**CITY OF GLENDALE, CA
DESIGN REVIEW STAFF REPORT – HILLSIDE SINGLE FAMILY**

September 10, 2020 <i>Decision Date</i>	3104 Sparr Boulevard <i>Address</i>
Administrative Design Review (ADR) <i>Review Type</i>	5613-022-039 <i>APN</i>
PDR 2007050 <i>Case Number</i>	Traci Ozzimo <i>Applicant</i>
Vista Ezzati, Planner <i>Case Planner</i>	Traci L. and Nance E. Ozzimo Trust <i>Owner</i>

The applicant is proposing to demolish the existing garage and to add a new 478 square-foot, attached, two-car garage and a 179 square-foot addition to the front of the existing one-story, 1,933 square-foot single-family residence (originally constructed in 1936) on a 7,686 square-foot interior lot, located in the R1R (FAR District II) Zone. The new two-car garage will be located in a similar location but closer to the street.

NEW SITE PLAN
1/8" = 1'-0"

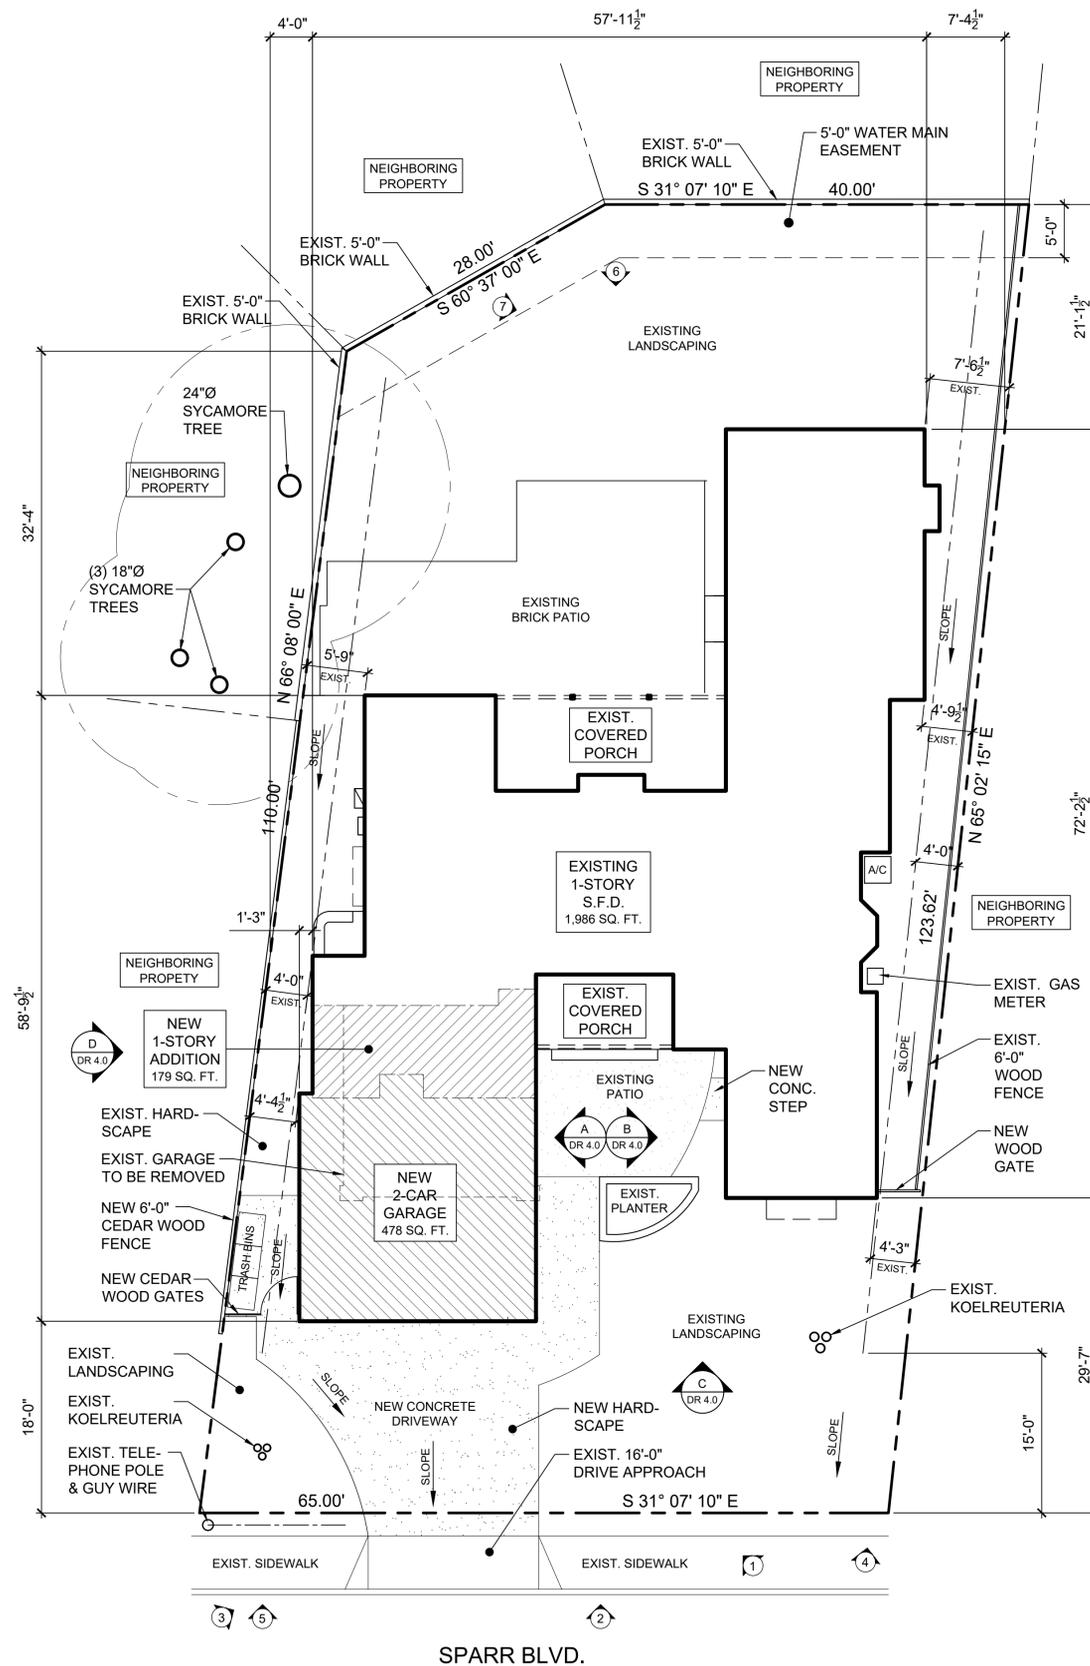
The plans indicate that the existing driveway hardscape will be removed, and a new concrete driveway is proposed. No other information is provided related to the driveway hardscape. The design guidelines call for decorative driveway paving materials and permeable paving systems are strongly encouraged. A condition of approval requires that the driveway be repaved with a decorative material consistent with the design with consideration given for a permeable paving material.

- Access to the new garage will be taken from the existing driveway apron, and the project includes replacing the existing driveway hardscape. A condition of approval requires the driveway to be repaved with a decorative paving material with consideration given to a permeable paver.

1. The driveway shall be repaved with a decorative material consistent with the design with consideration given for a permeable paving material.
